**Hungarian Academy of Sciences  
KFKI Atomic Energy Research Institute**

Comments on Proposed Rulemaking on  
Performance Based Emergency Core Cooling Criteria  
RIN 3150-AH42 (NRC-2008-0332)

Fig. 1. Load-displacement curves showing the ductile-to-brittle transition in RCT (left) and ring tensile (right) tests (AEKI experiments)

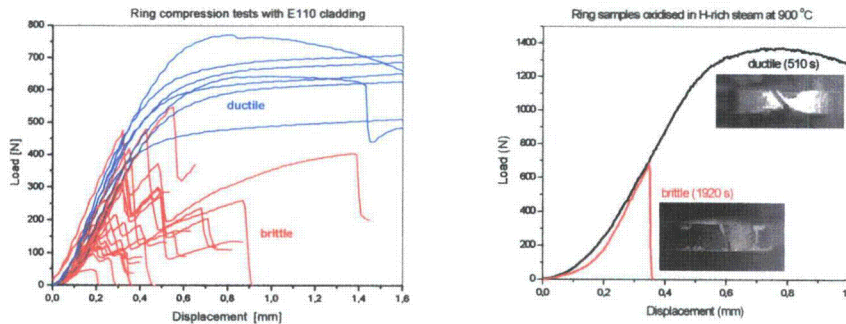
Point IV.6.d.2. defines 1% permanent strain as a measure of cladding ductility. Zero ductility (or ductile-to-brittle transition or embrittlement threshold) could be easily determined on the basis of load-displacement curves. The ductile material is characterised by a ductile plateau after elastic section and when it is missing the material has some degree of embrittlement (Fig. 1). The load displacement curves of compression, tensile and bending tests have the same character, and any of them can be used to characterise the ductile-to-brittle transition. If we judge the zero ductility by the shape of the curve we do not need to introduce specific parameters as e.g. permanent strains or strain energy which are derived from the curves.
